**Proposed Comments from ECC, to be submitted before 23 July 2018**

To: Mike Howard, Auburn State Recreation Area Superintendent  
Subject: ECC Recommendations on the ASRA June 2018 Draft General Plan  
Date: 15 July Draft (ps)  
Reply to: Cynci, ECC Secretary; [endurancecapital@ncbb.net](mailto:endurancecapital@ncbb.net); 530-823-2661

Clementine, North Fork Trails

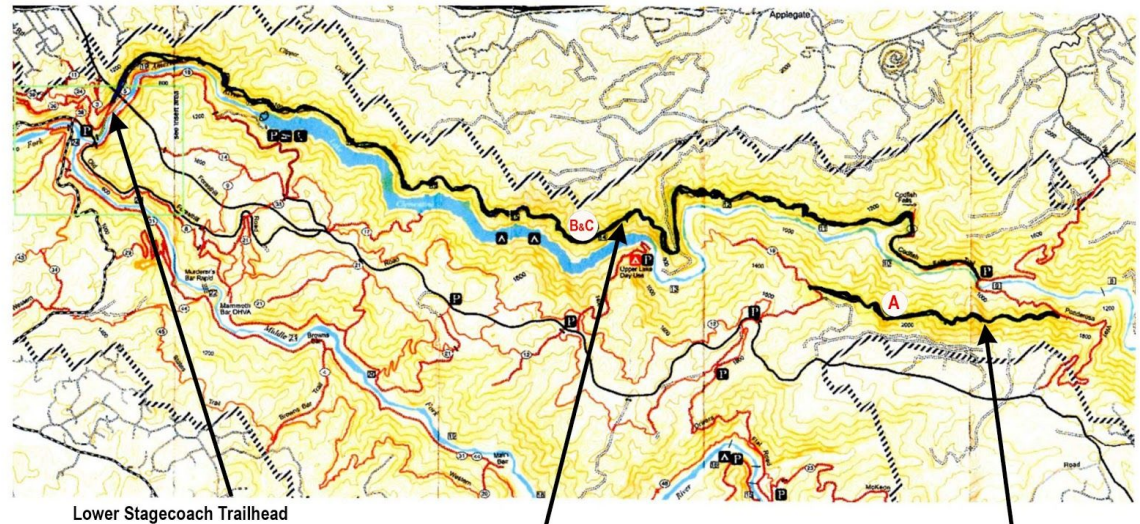
- 1.D. (Not in General Plan Summary) North Fork Trail: explanation from Cynci - This was on the table prior to the most recent General Plan meetings, but was in a “mapping stage” only. It would go from the lower Stagecoach Trailhead via the Clark’s Hole Trail to connect to a new trail. The new trail would follow the north side of Lake Clementine and the Upper North Fork of the American River all the way to Ponderosa Way Crossing (bridge by the Codfish Falls Tailhead outside of Forest Hill). Use designation would be decided by the condition of the trail once it was built, but the hope would be for multi-purpose. **I see no mention of this in the most recent General Plan material and the ECC needs to push for this to be included.**

- Auburn to Cool Trail
- Confluence to Ponderosa Road (should be “Way”) Crossing - *Note from Cynci: Ponderosa Way Crossing is a bridge on Ponderosa Way at the Codfish Trail Trailhead. It spans the North Fork of the American River outside of Foresthill. The “North Fork Trail” would follow the north side of Lake Clementine and the Upper North Fork of the American*

River from the confluence near the Lower Stagecoach Trailhead to this bridge. Map below.  
I clarified the map from the prior version.

- Lower Stagecoach Trailhead
- (A) Connection from Foresthill Loop to Ponderosa Way using a portion of #19 Long Point Fuel Break Trail 
  - (B) Connection from Confluence at Lower Stagecoach Trailhead/Clarks Hole Trail to the (to be built) North Fork Trail. 
  - (C) Revive the North Fork Trail Plan.
